## PRODUCT SAFETY BULLETIN

**Product:** 370 X cutter

**Description:** Notch in Clevis may not be deep enough

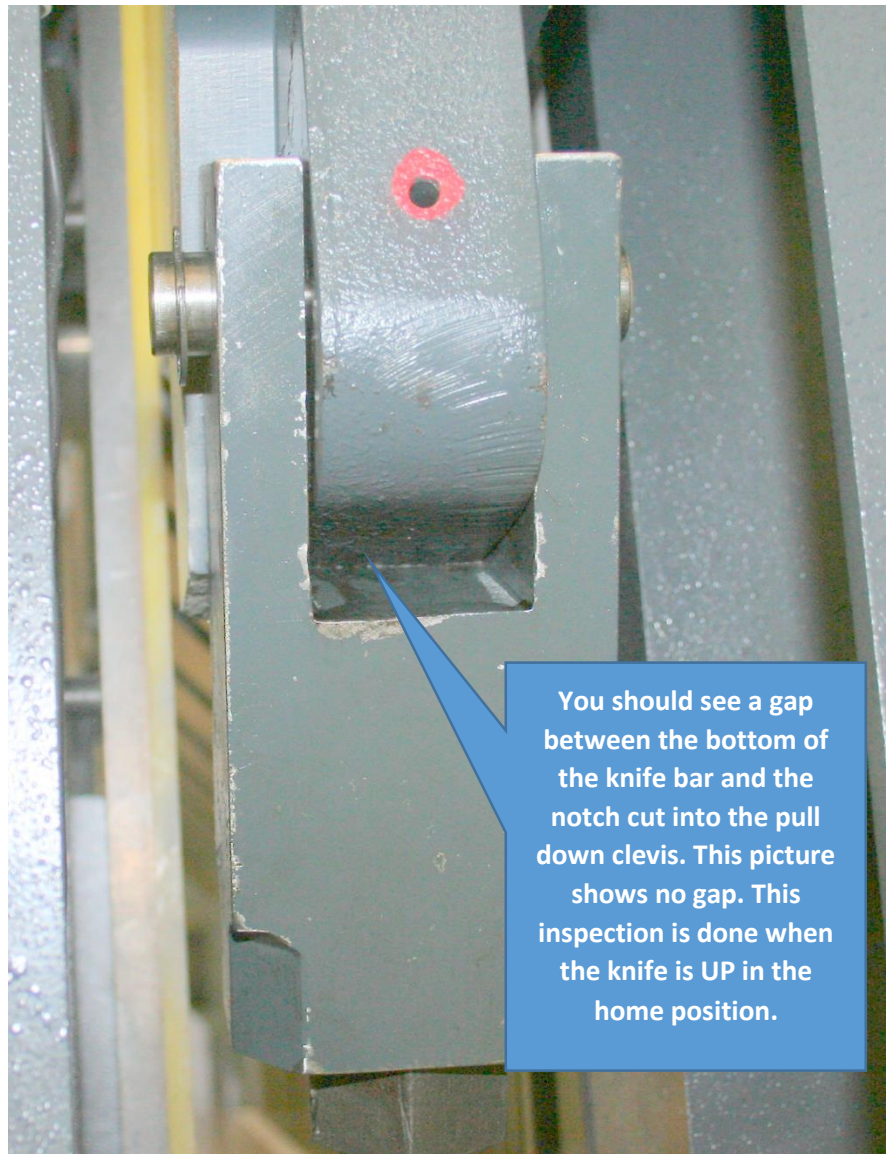
This inspection should be done when the knife is in the up position and the power to the machine turned OFF. You should see a gap between the notch cut in the knife pull down clevis and the knife bar casting. See photo, in this photo there is no gap. If your machine does not have a gap at this location contact Challenge Machinery for a replacement clevis.

You should see a gap between the bottom of the knife bar and the notch cut into the pull down clevis. This picture shows no gap. This inspection is done when the knife is UP in the home position.
